**North Donahue Widening Phase 1
City of Auburn, Alabama**

**Addendum 2
September 18, 2026**

CITY OF AUBURN
NORTH DONAHUE DRIVE WIDENING

UTILITY PLAN - N. DONAHUE DRIVE
STA 0+00 - 14+00

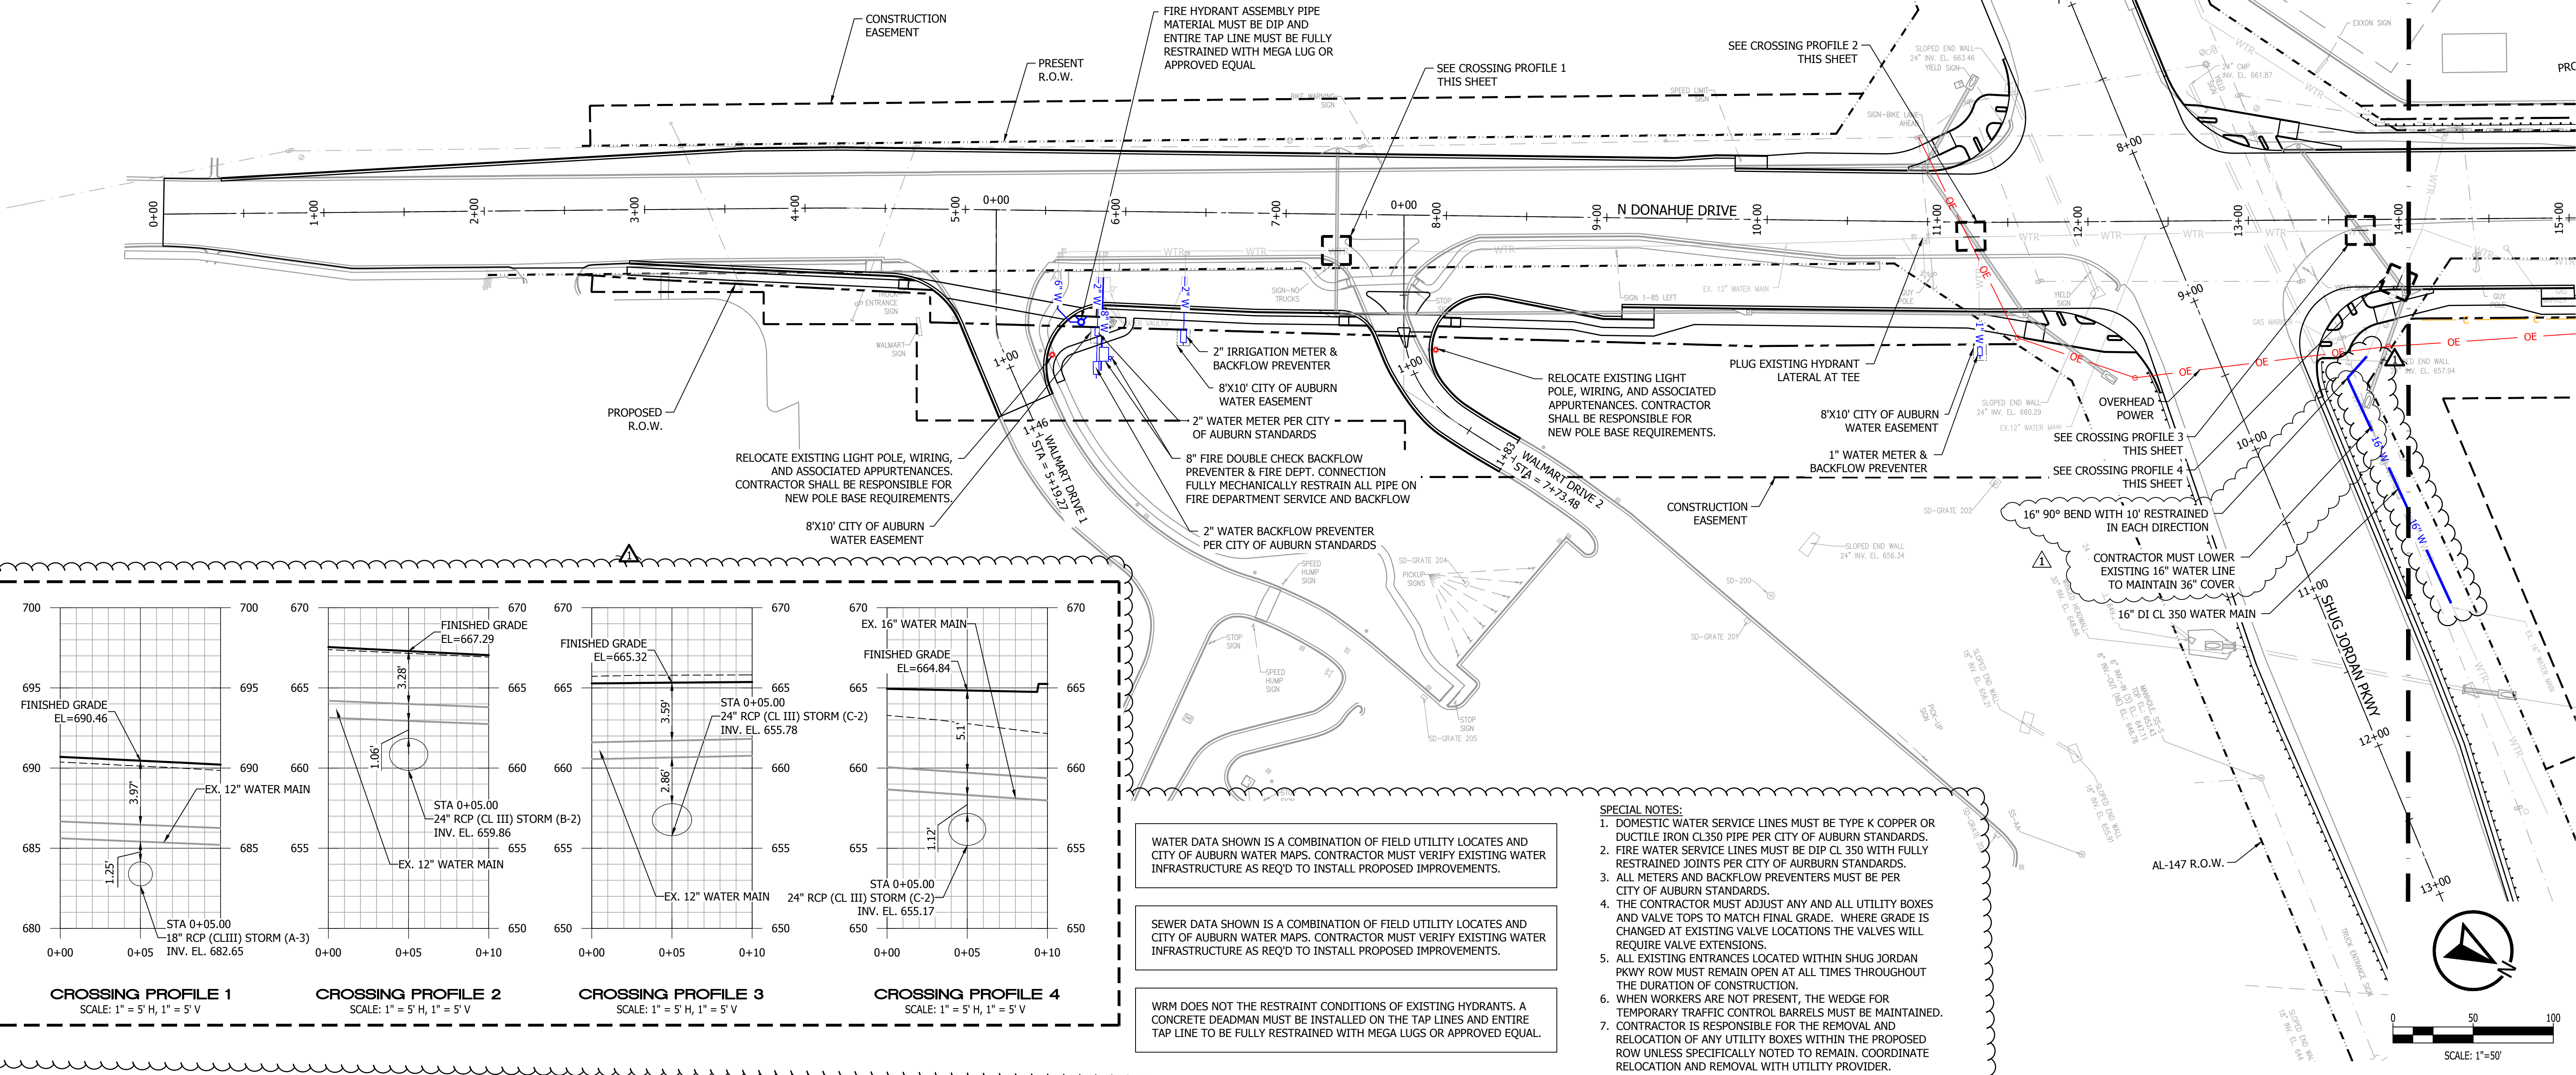
1. Added pay item for the green bike lane striping under 703H000 Specialty Traffic Control Markings
2. Added pay item 640A005 Underground Utility Adjustment
3. Updated plan sheets for utilities
